SERVICE BULLETIN

M-1014

SPORTSTER GAS TANK HARDWARE

Figure 1. Installation for Tanks With "1" On Tab

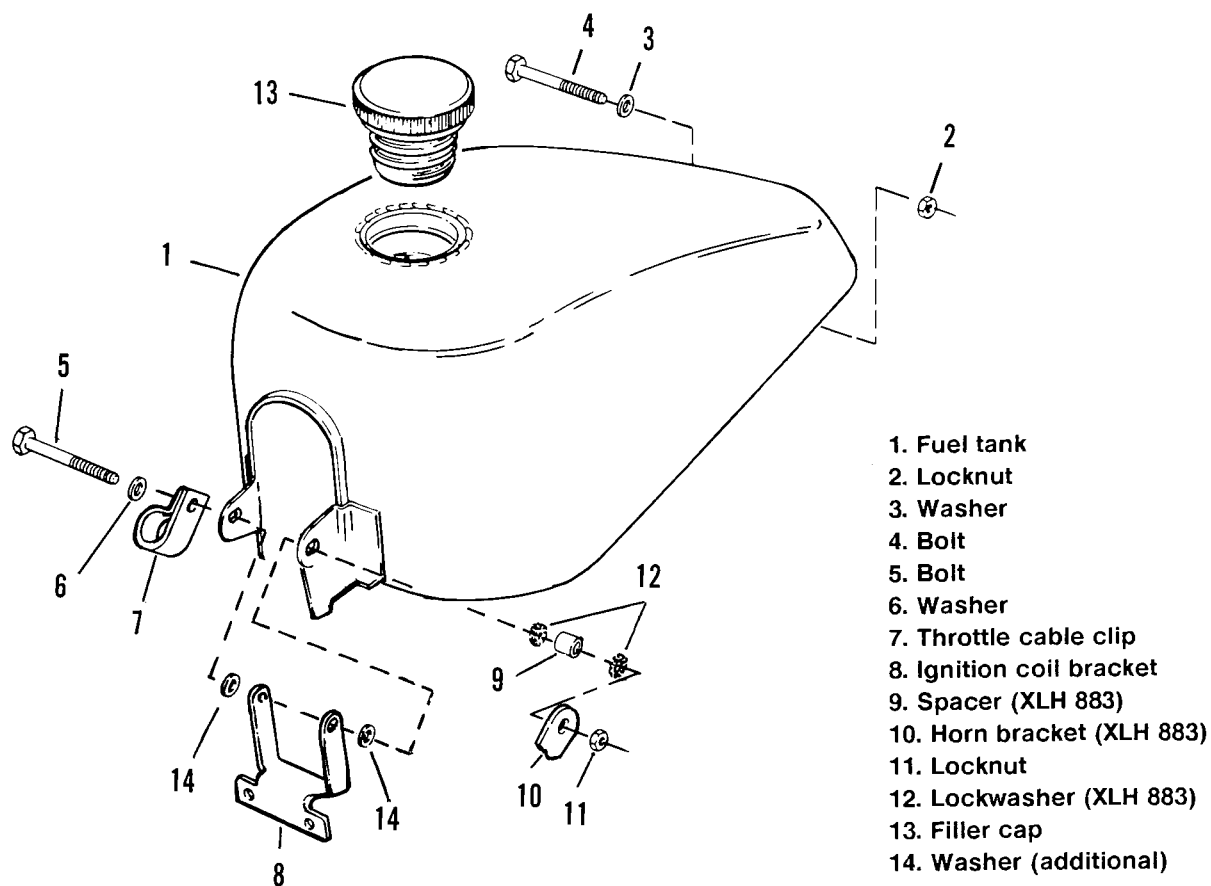
This Service Bulletin is being issued to make service technicians aware of a situation they may encounter when removing and installing stock 1991 Sportster gas tanks. Additional washers will need to be used to install Sportster gas tanks that have the number "1" stamped on the front mounting tab. Without these additional washers, the gas tank will not mount properly, possibly resulting in gas tank rattling or paint chipping, or damage to mounting brackets.

See Figure 1. To identify this situation, locate the front mounting tab of 1991 XL 883 and 1200 model vehicles. If the number "1" is stamped on the outside of the front mounting tab, additional washers will need to be used on this installation. The additional washers are to be positioned between mounting tabs on the gas tank and coil mounting bracket.

For 1991, XL 883 models with "1" stamped on front mounting tab, use the following hardware components:

QTY	DESCRIPTION	PART NO.
1	Bolt	4100HW (Coarse)
2	Washer	6400HB
2	Washer	6702 (Additional)
1	Nut	7531 (Coarse)

For 1991, XL 1200 models with "1" stamped on front mounting tab, use the following hardware components:

QTY	DESCRIPTION	PART NO.
1	Bolt	3409 (Fine)
2	Washer	6400HB
2	Washer	6702 (Additional)
1	Nut	7577 (Fine)
